**Re: Draft Plan of Subdivision: Menzie Enclaves**  
**County of Lanark Fileno# 09-T-23006**

**RESPONSE TO AGENCY COMMENTS**

**Re: Second Submission Comment Letter – Subdivision Application  
Menzie’s Enclave  
09-T-23005 (County File Number)**

**Re:** Draft Plan of Subdivision – 09-T-23006 – Menzie Enclaves Subdivision, Municipality of Mississippi Mills

TITLE:  
**DRAFT PLAN OF SUBDIVISION OPTION 3**

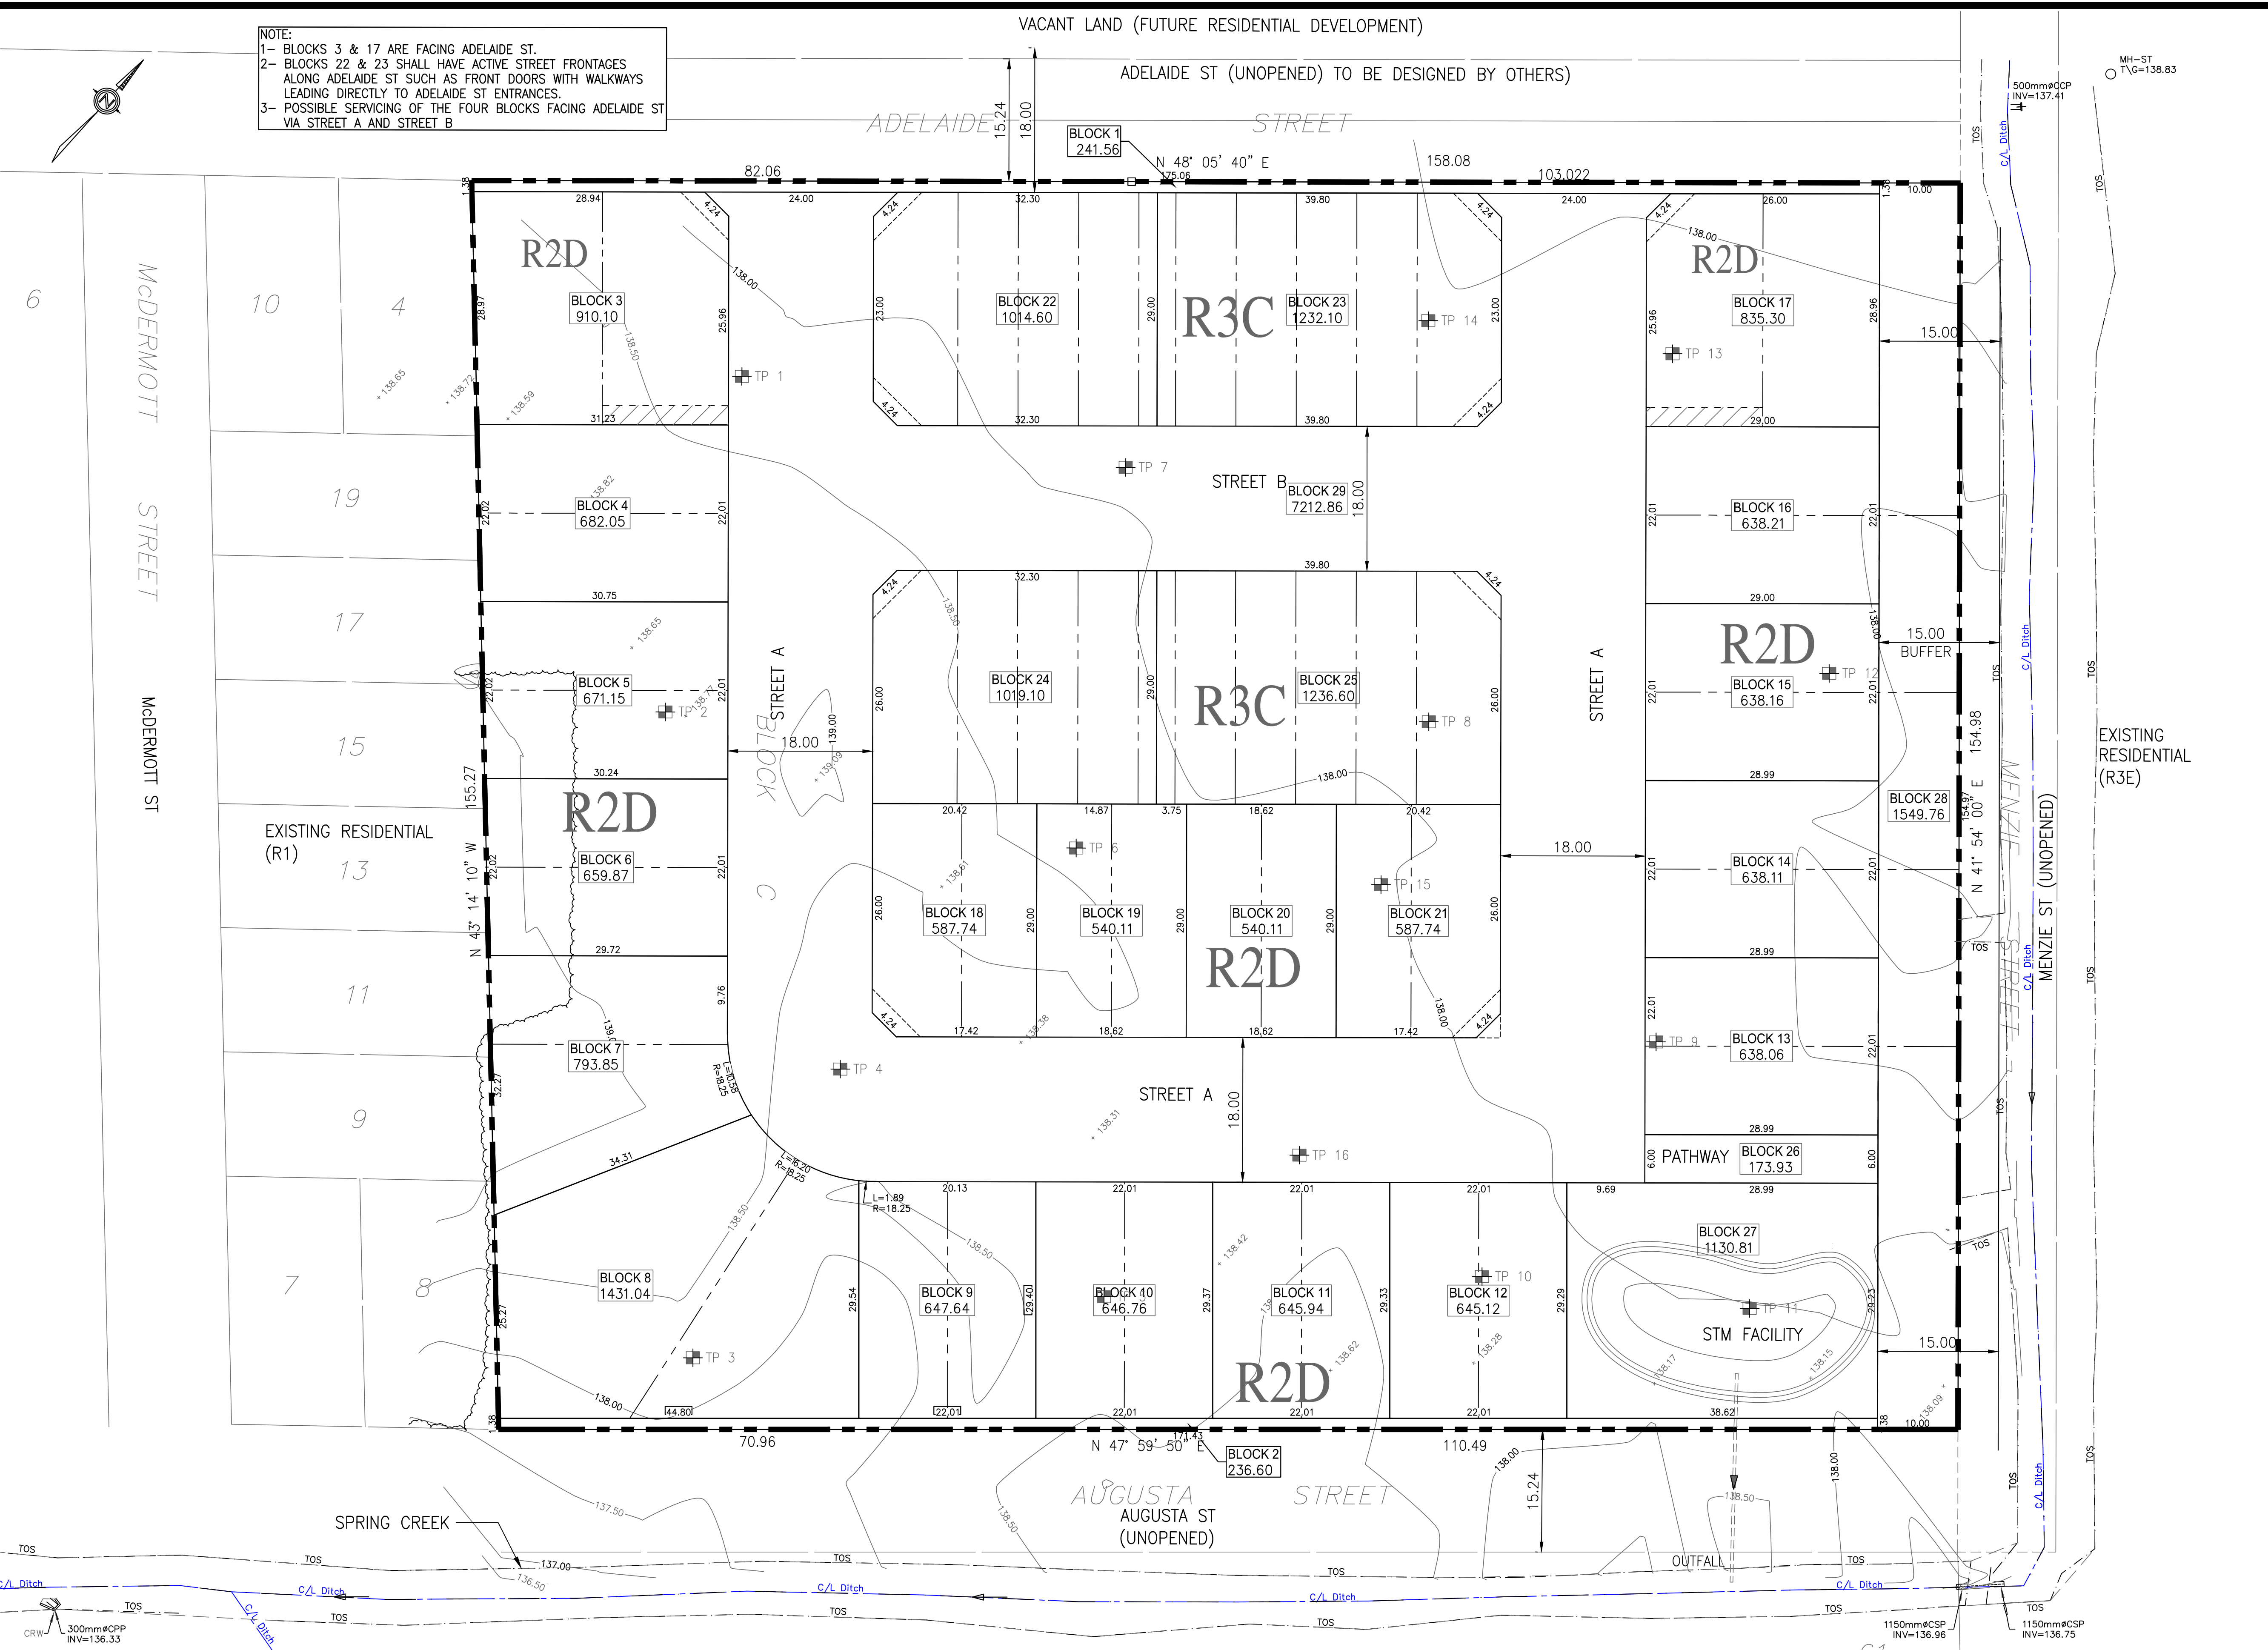
1. Based on the alternative plan submitted, the proposed density is 19.7 units per gross hectare (29 units per net hectare) and a split of 67% low density residential and 33% medium density residential; however, it is noted that the resolution of the plans makes the plans difficult to read. Assuming the foregoing is correct, it appears the lot configuration meets the intent of the Official Plan policies as it relates to residential development.

2. Based on the site plans for the townhomes, it appears that the design of the rear yards fronting onto Adelaide is a typical rear yard with no pedestrian connections to Adelaide Street. Consider flipping the orientation of the townhouses so that units front onto Adelaide Street and the rear of the units back onto Street B.

3. Please provide a PDF copy of the revised alternative plan which is of a higher resolution so that setbacks and lot areas can be reviewed in greater detail.

NOTE:  
 1- BLOCKS 3 & 17 ARE FACING ADELAIDE ST.  
 2- BLOCKS 22 & 23 SHALL HAVE ACTIVE STREET FRONTS ALONG ADELAIDE ST SUCH AS FRONT DOORS WITH WALKWAYS LEADING DIRECTLY TO ADELAIDE ST ENTRANCES.  
 3- POSSIBLE SERVICING OF THE FOUR BLOCKS FACING ADELAIDE ST VIA STREET A AND STREET B

**AE: We will keep the alternative option since it complies better with the Official Plan.**

**AE: There is a pedestrian connection for the townhouses to Adelaide St. We will make the principal elevation the one facing Adelaide and the driveway and services will be accessible from Street B.**
